# Mobile Intel® Pentium® 4 Processor-M

## Specification Update

*May 2005*

Document Number: 250721-029

Figure 13. System Bus Reset and Configuration Timings

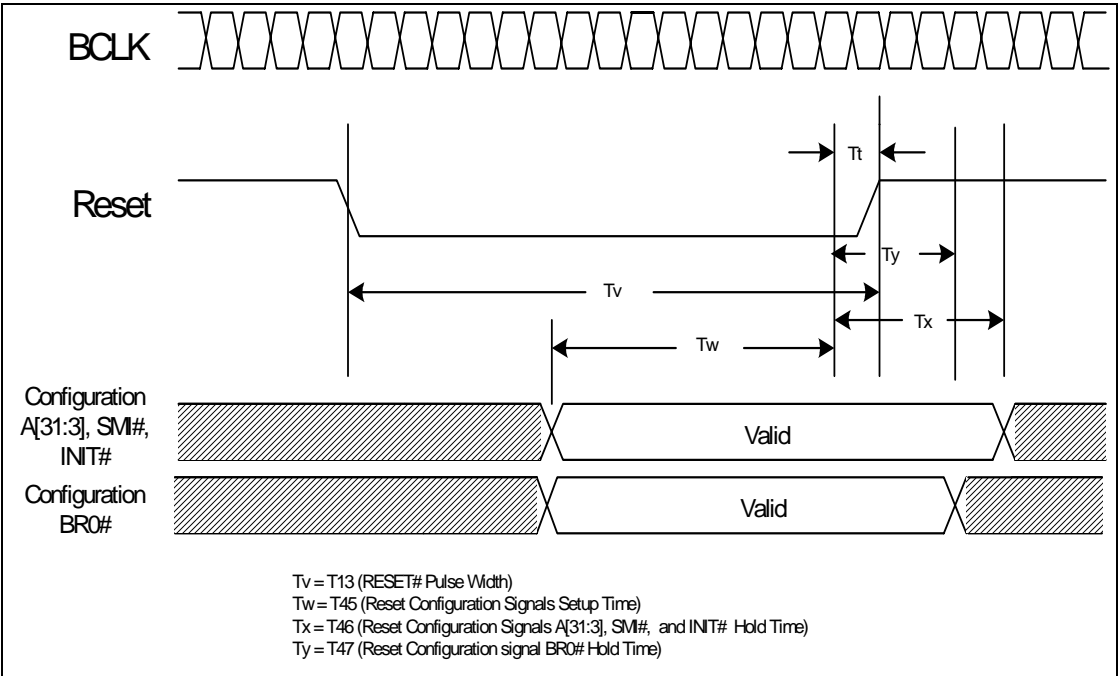
## T2. BR0# Maximum Hold Time Specification Change

The BR0# maximum hold time has changed to 2 BCLKs. This change will be shown in the “System Bus AC Specifications (Reset Conditions)” table and “System Bus Reset and Configuration Timings” figure of the *Mobile Intel® Pentium® 4 Processor - M Datasheet*. This change will be incorporated in the next revision of the datasheet.

The following figure will be modified to reflect this change:

T# Parameter	Min	Max	Unit	Figure	Notes
T45: Reset Configuration Signals (A[31:3]#, BR0# INIT#, SMI#) Setup Time	4		BCLKs	13	1
T46: Reset Configuration Signals (A[31:3]#, INIT#, SMI#) Hold Time	2	20	BCLKs	13	2
T47: Reset Configuration Signal BR0# Hold Time	2	2	BCLKs	13	2

1. Before the deassertion of RESET#.
2. After clock that deasserts RESET#.
